Service Bulletin SB 2X-27-14 R3

Revised: 10 Oct 2007

Models SR20 and SR22

ATA 27-00: Flight Controls Rudder-Aileron Interconnect Modification

Figure 01 - Rudder-Aileron Interconnect Modification

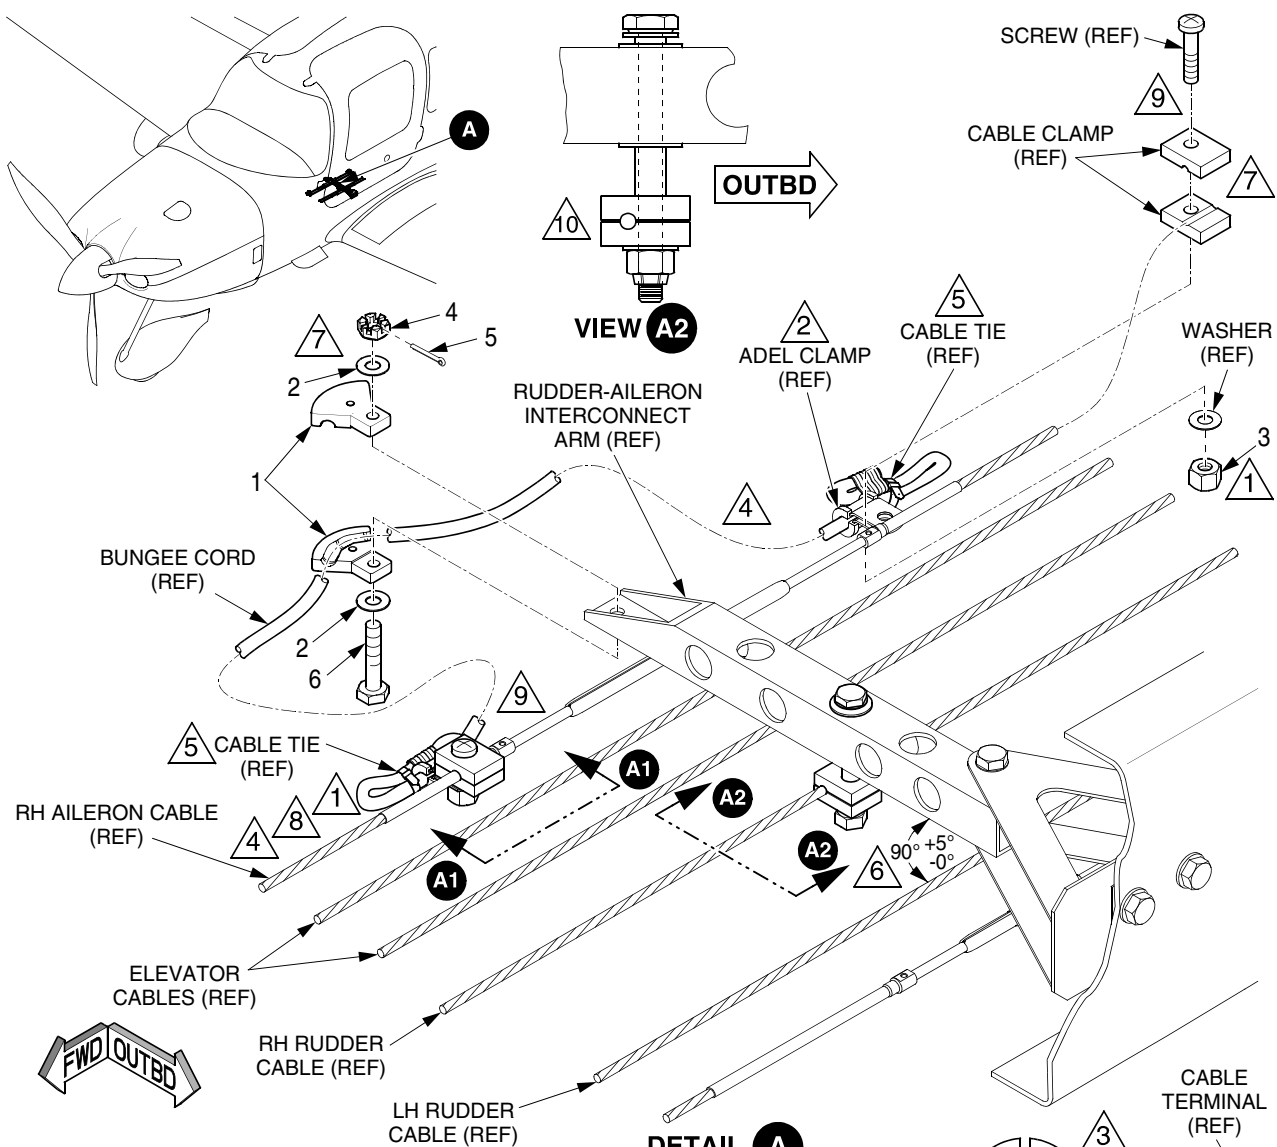
- add new attaching parts, including an improved bungee clamp that replaces the existing Adel clamp at the end of the rudder-aileron interconnect arm,
- re-orient existing cable clamps 180° at RH rudder cable,
- clarify security of attaching parts and orientation of bungee cord ends,
- change effectivity, and
- change manhours.

- J. To increase clearance between LH and RH rudder cables, re-orient RH rudder cable clamps.
1. At middle of rudder-aileron interconnect arm, remove nut securing bolt, washers, and cable clamps to RH rudder cable. Discard nut.

2. Rotate rudder cable clamps 180° so that RH rudder cable is inboard of cable clamp attach bolt.
 3. Install nut (item 3) securing bolt, washers, and cable clamps to RH rudder cable. Torque nut between 20 - 25 in-lb (2.3 - 2.8 Nm).

- K. Remove and discard bolt, washers, spacer (if installed), Adel clamp, and nut securing bungee cord to rudder-aileron interconnect arm.

- M. Position upper and lower bungee clamps (item 1) over center of bungee cord.
- N. Position bungee clamps to end of rudder-aileron interconnect arm so that arm is located between upper and lower bungee clamps.

Note: Orient bolt so that bolt head is positioned downward. (See Figure 01)

- O. Install bolt (item 6), washers (item 2), bungee clamps, nut (item 4), and cotter pin (item 5) securing bungee cord to rudder-aileron interconnect arm. Torque nut between 43 - 47 in-lb (4.9 - 5.3 Nm).
- P. At forward and aft ends of bungee cord, remove screws, washers, cable clamps, and nuts securing bungee cord Adel clamps to RH aileron cable. Discard nuts.
- Q. If installed, remove cable ties securing bungee cord ends to itself.
- R. At forward aileron cable, position cable clamps against the swage end of the cable terminal. Ensure cable clamps are not installed over tapered end of swage.

- S. Install screw, washer, cable clamps, and nut (item 3) securing forward bungee cord Adel clamp to RH aileron cable. Torque nut between 45 - 50 in-lb (5.1 - 5.6 Nm).
- T. At aft aileron cable, position cable clamps against the swage end of the cable terminal. Ensure cable clamps are not installed over tapered end of swage.

- U. Install screw, washer, cable clamps, and nut (item 3) securing aft bungee cord Adel clamp to RH aileron cable. Torque nut between 45 - 50 in-lb (5.1 - 5.6 Nm).
- V. Perform Adjustment/Test - Rudder-Aileron Interconnect.
 - 1. Verify rudder-aileron interconnect arm is perpendicular to the control cables.
 - 2. Position WS 144 rigging template on wing.
 - 3. Verify full LH rudder deflection causes 5° - 8° RH aileron trailing edge down.
 - 4. Verify full RH rudder deflection causes 5° - 8° LH aileron trailing edge down.
 - 5. If downward motion is less than 5°, too much slack exists. Reduce slack by pulling bungee cord from forward and aft cable clamps away from interconnect arm.
 - 6. If downward motion is greater than 8°, too much tension exists. Reduce tension by pulling bungee cord from forward and aft cable clamps toward interconnect arm.

1. Torque nut to 45 - 50 in-lb (5.1 - 5.6 Nm).
2. Verify adel clamps are parallel to cable clamps.
3. Install cable clamp against the swage end of the cable terminal. Ensure cable clamps are not installed over tapered end of swage.

4. Fold bungee cord end towards the clamp and install cable tie securing bungee cord end to itself. Position excess bungee cord below cable clamps to eliminate any interference with bottom of interconnect arm.

5. Ensure cable tie is tightly secured and snug against the clamps.
6. To prevent interference with adjacent control cables, forward edge of rudder-aileron interconnect arm must be oriented 90° +5°/-0° to the control cables.

7. It is permissible to add an additional washer (NAS1149F0363P) to ensure correct thread engagement.
8. If not oriented properly, the cable clamps may interfere with attaching hardware at the bungee clamps. Verify cable clamps are positioned so that screws are oriented vertically.

9. Do not install washer below head of screw. Only one washer is required at nut.
10. *RH rudder cable only:* To increase clearance between LH and RH rudder cables, rotate rudder cable clamps 180° so that RH rudder cable is inboard of cable clamp attach bolt.
